Responsiveness Summary

**Lower Fox River and Green Bay,
Wisconsin Site**

**Record of Decision, Operable Units
3, 4, and 5**

June 2003

Figure 1 Graphical Representation of Lake Winnebago Stages Comparing 2003 Levels vs. 2002 Levels in feet, Oshkosh

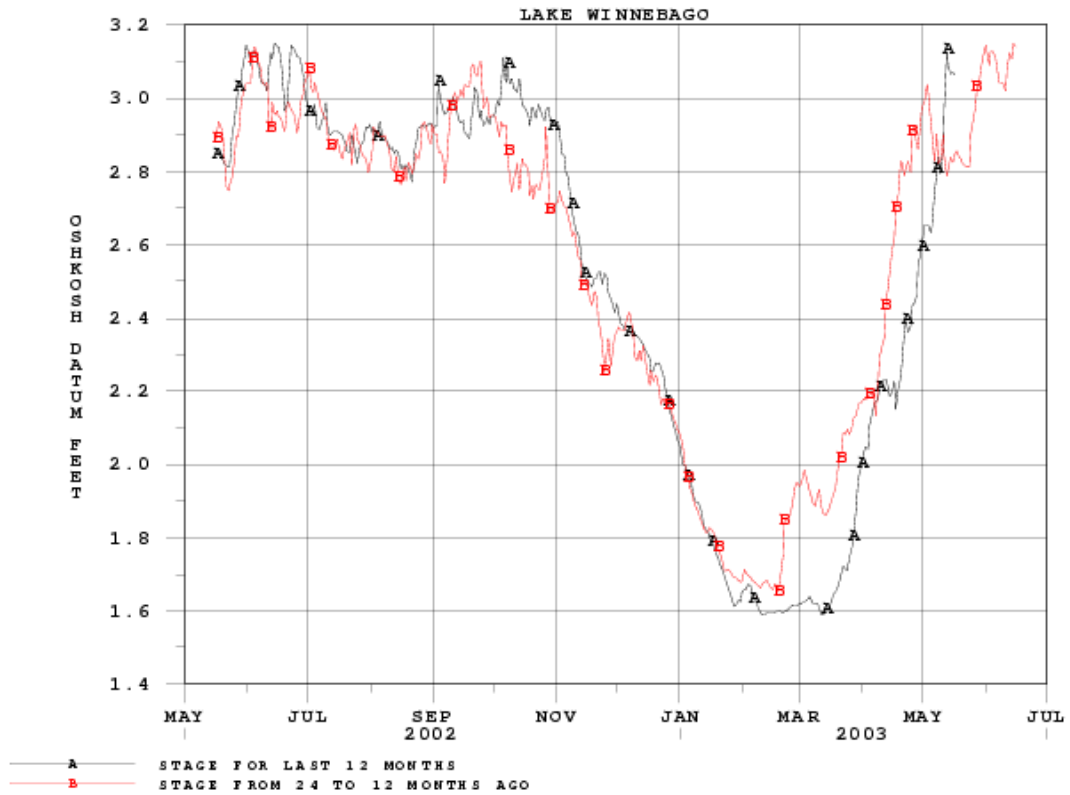
Master Comment 2.35

Dams at Menasha and Neenah control the Lake Winnebago water level. The dam and lock systems in place in the Lake Winnebago-Lower Fox River system are managed using the Linde Plan (USACE, 1998a) as a management guide; the dam and lock systems are primarily intended to provide water for hydropower and navigation while preserving or enhancing fish, wildlife, and wetland habitat and water quality in the Lower Fox River and the Lake Winnebago pool. The USACE Great Lakes Hydraulics and Hydrology Branch of the Detroit District has regulated the water level of Lake Winnebago using the Linde Plan since the early 1980s, and the target level represents a compromise reached between the needs of hydropower generation and navigation, not flood control.

- Localized heavy precipitation on the water surface, causing a rapid rise in water elevation
- Flooding in the Lake Winnebago pool and/or the Lower Fox River (due to high outflows) during the snowmelt
- Frazil ice that clogs hydropower and industrial water intakes, causing plants to shut down and thus resulting in upstream flooding and reduction of downstream flow
- Wind actions (northeast, east, or southeast) causing a condition referred to as “wave run-up,” which is a wave action causing flooding and erosion

Flooding of the Lower Fox River generally requires several days to develop. The graphical representations in Figures 1 and 2 from the USACE website (http://www.lre.usace.army.mil/index.cfm?chn_id=1072#Flood) indicate increases in the outflow of Lake Winnebago. Note that in the 1998 to 1999 period, maximum outflow for July indicates an event in which large water volume releases occurred from Lake Winnebago in an abrupt discharge, which suggests concern for flooding and excessive erosive force in the Lower Fox River.
